MEETING NOTICE – SITE REVIEW COMMITTEE

Date/Time: Wednesday September 21st 2022 (5:30 P.M.)

RE: 3828 Packerland Dr., HB-950-7; New 11,890 Square Foot Industrial Building, office/shop/warehouse with associated site improvements

ISSUE: Discussion and action on a new 11,890 square foot commercial building and associated site improvements

BUILDING ELEVATION - WEST
1 / A2.0 SCALE = 1/8" = 1'-0"

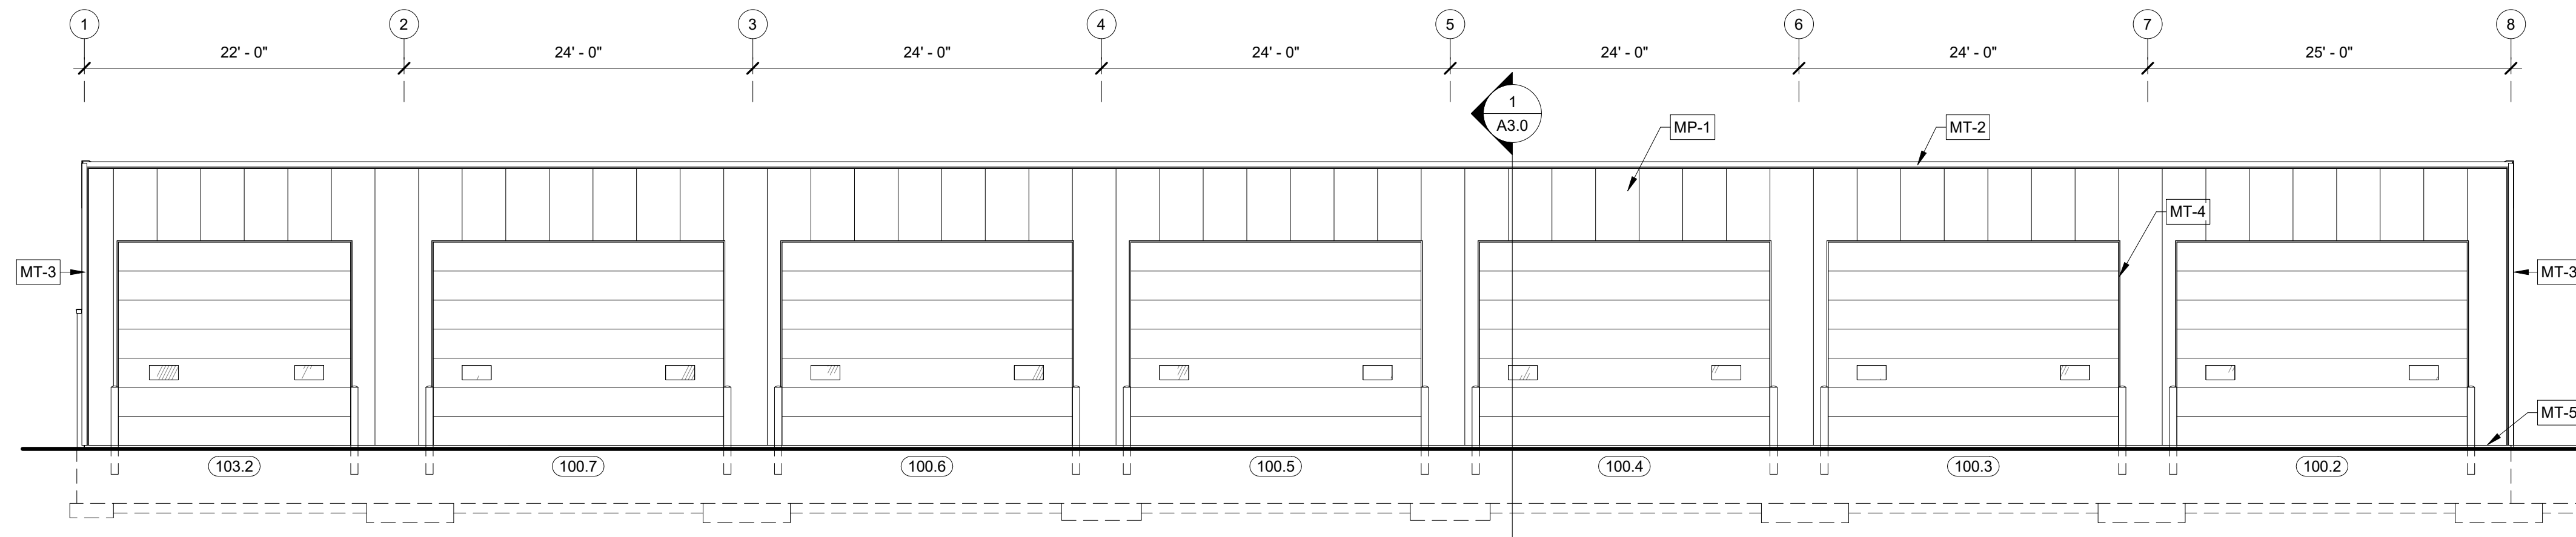
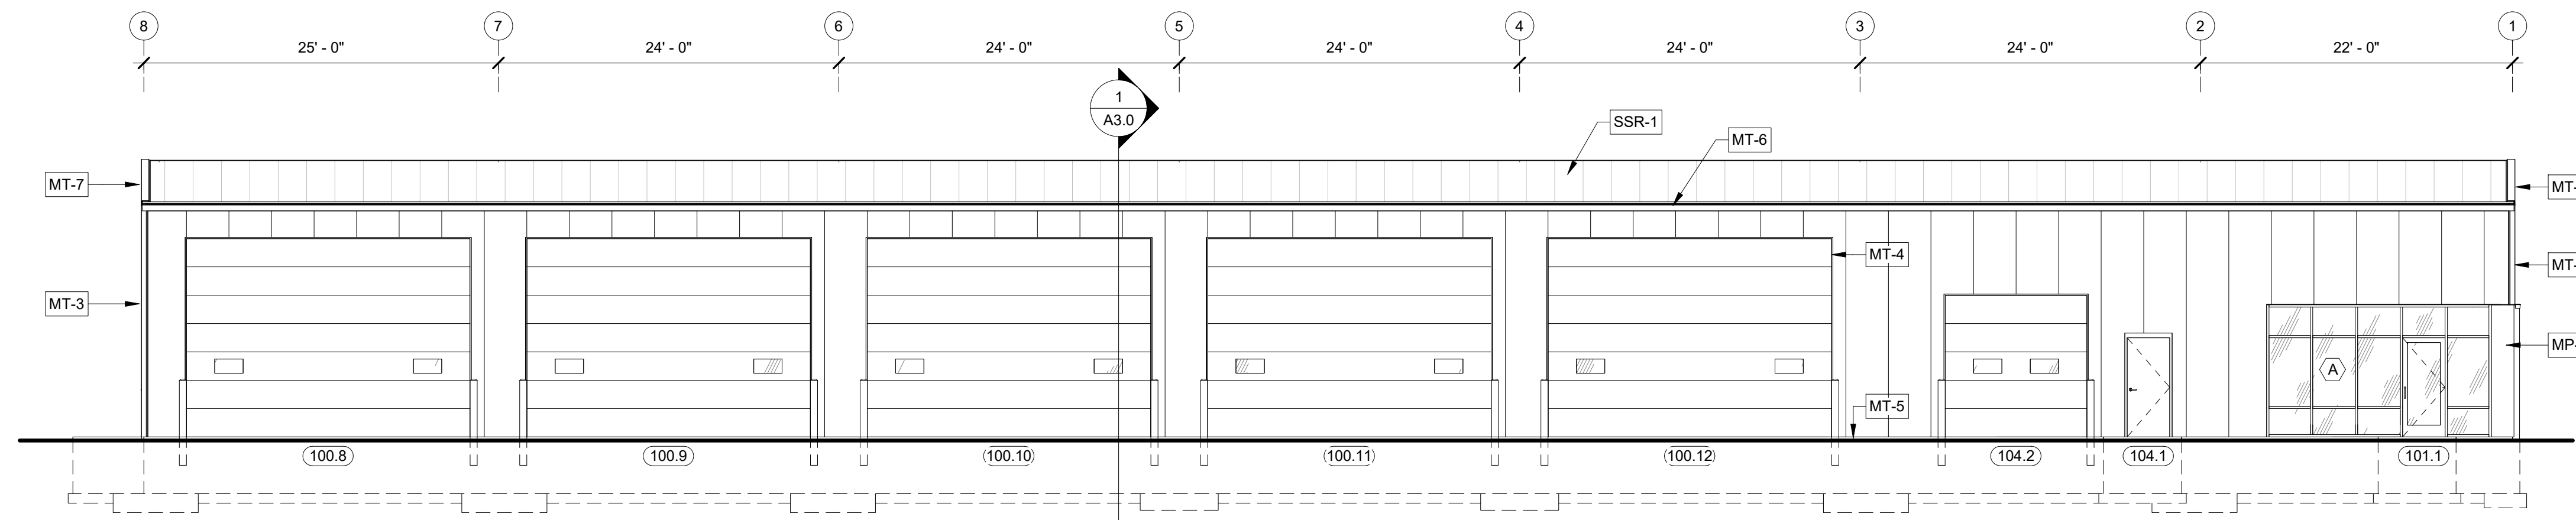
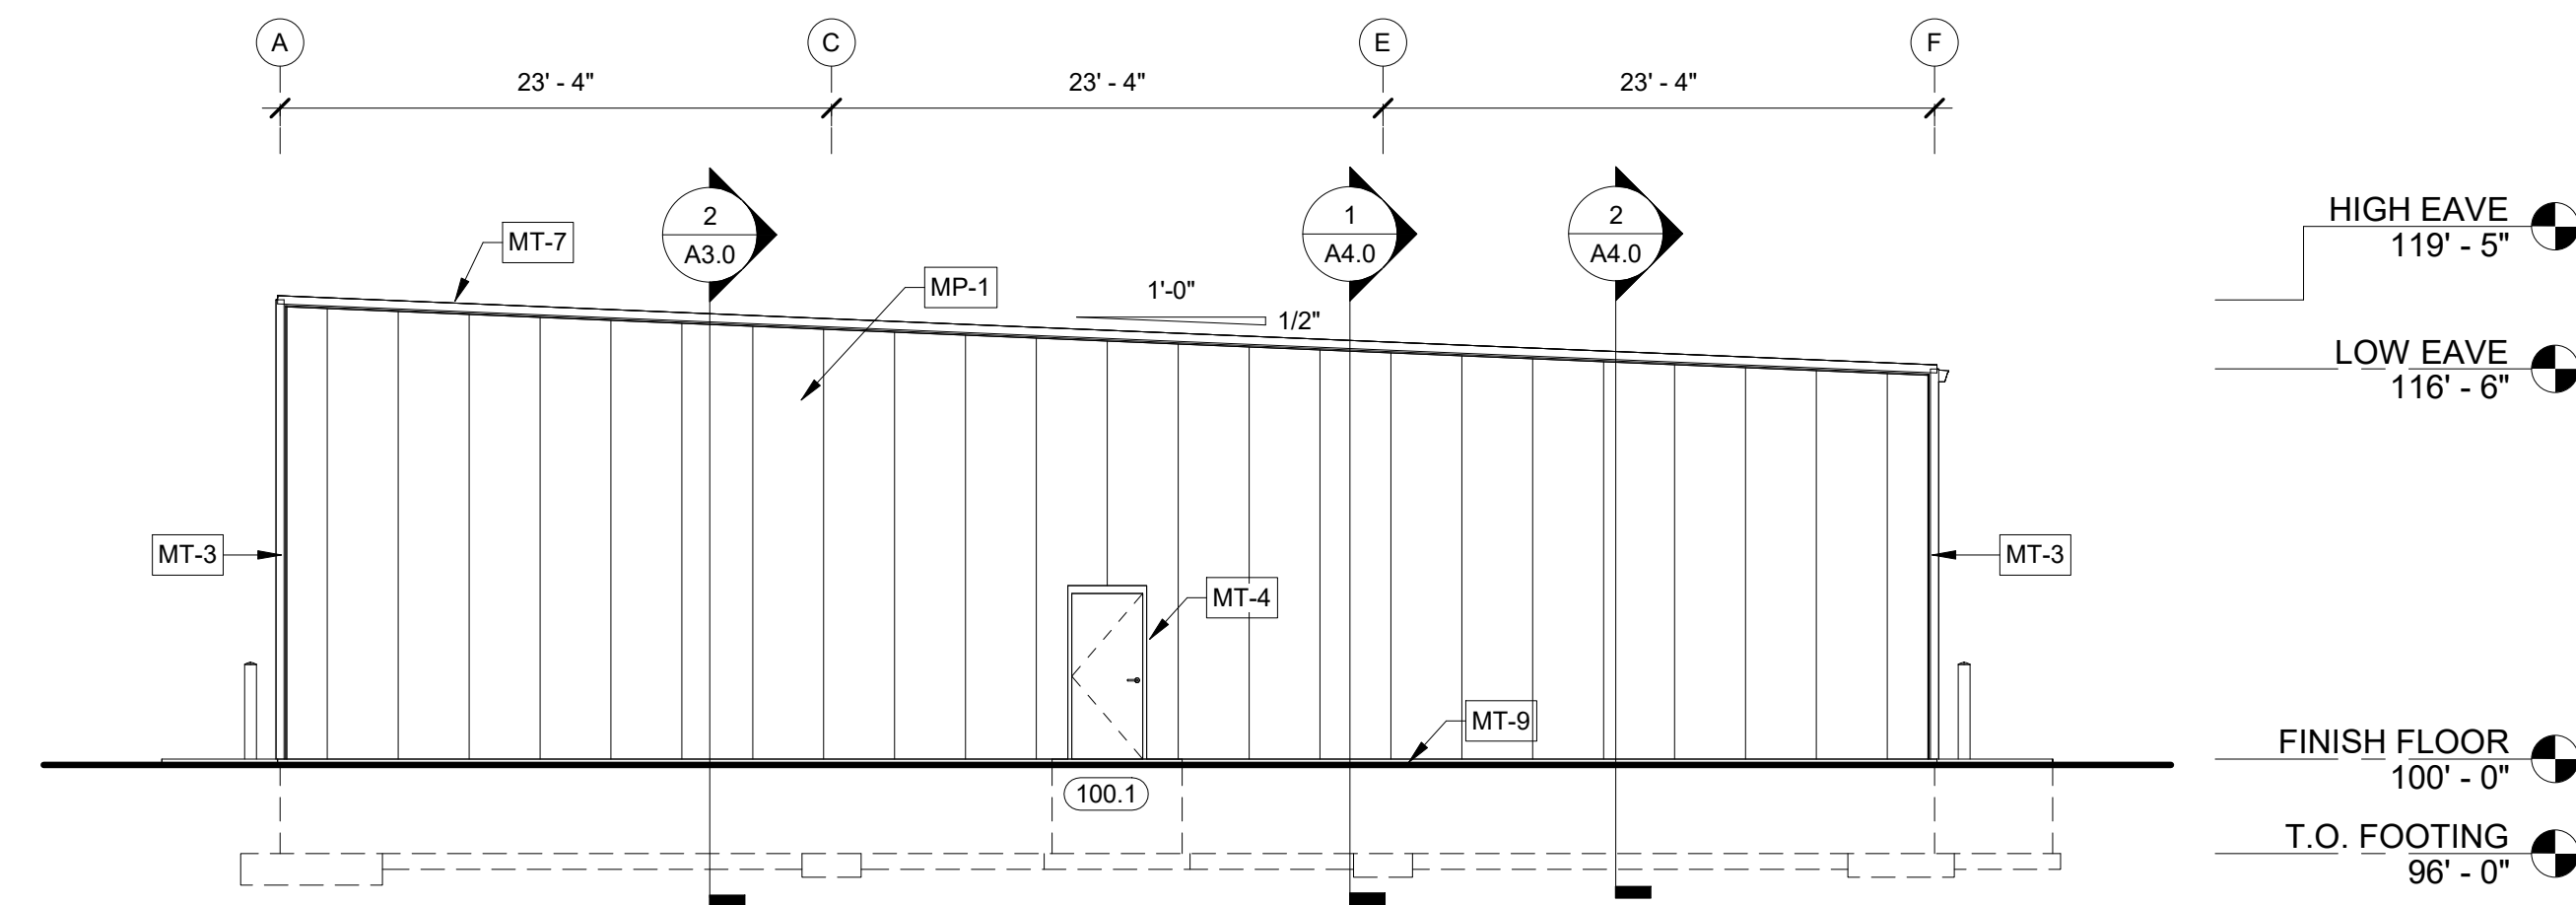
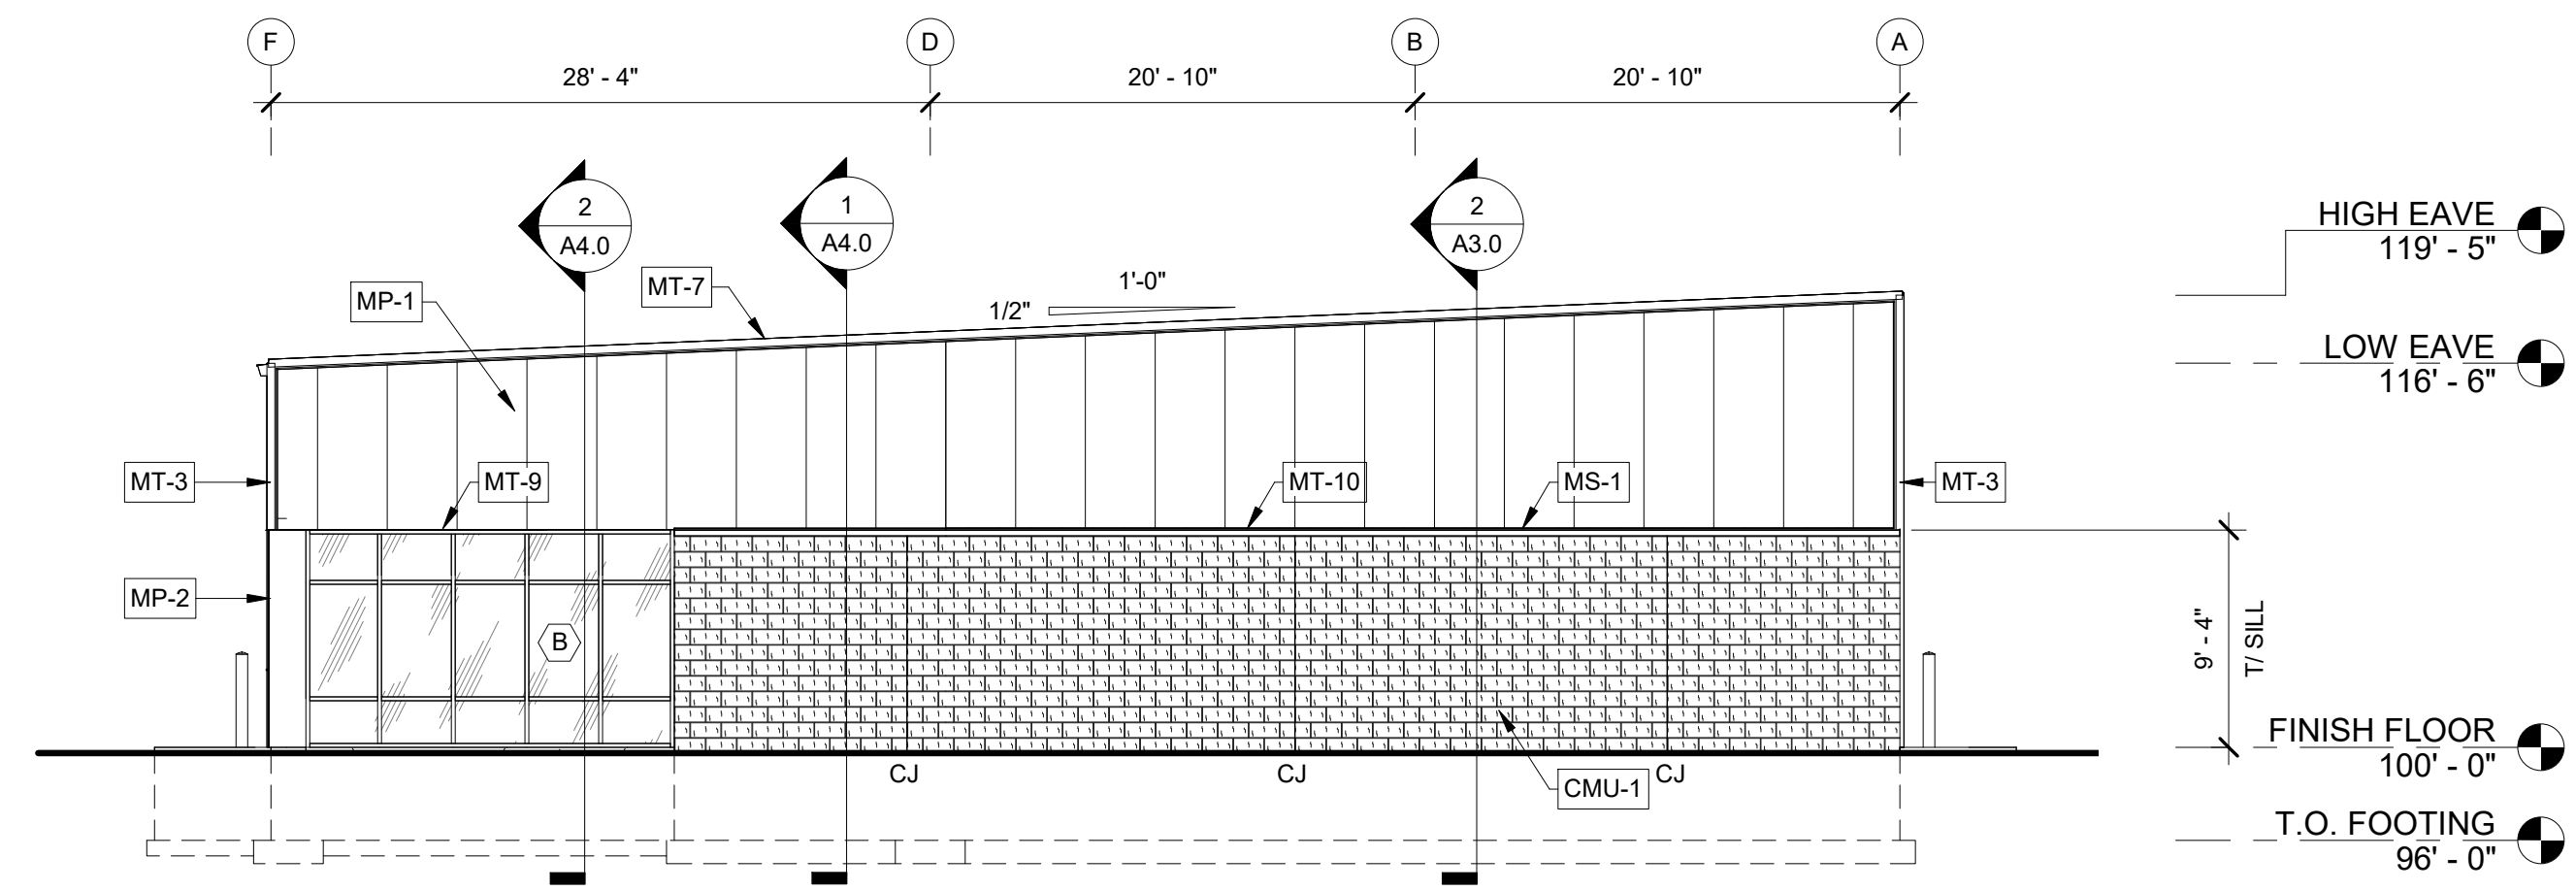
1. **Materials:** Metal frame building
2. **Exterior Materials:** Front wall of building facing Packerland Dr. will have a combination of split face CMU veneer and semi-concealed fastener metal wall panel wall panels. As for the percentage of masonry along the front elevation, the plan meets the minimum 35% masonry along the front elevation of the building.
3. **Height:** Overall height of 19'-5"
4. **Overhead doors:** All overhead doors on located on the north and south building elevations which are both side walls of the proposed building.
5. **Mechanical equipment:** There is no mechanical equipment shown, however, any roof mounted equipment shall be screened from view by materials compatible with the primary building.

1. Screening of any roof mounted HVAC equipment with materials similar to those utilized for the principal building
2. Implementation of a total of 5 deciduous trees along the public roadway
3. Any proposed signage shall come back to the Committee for approval
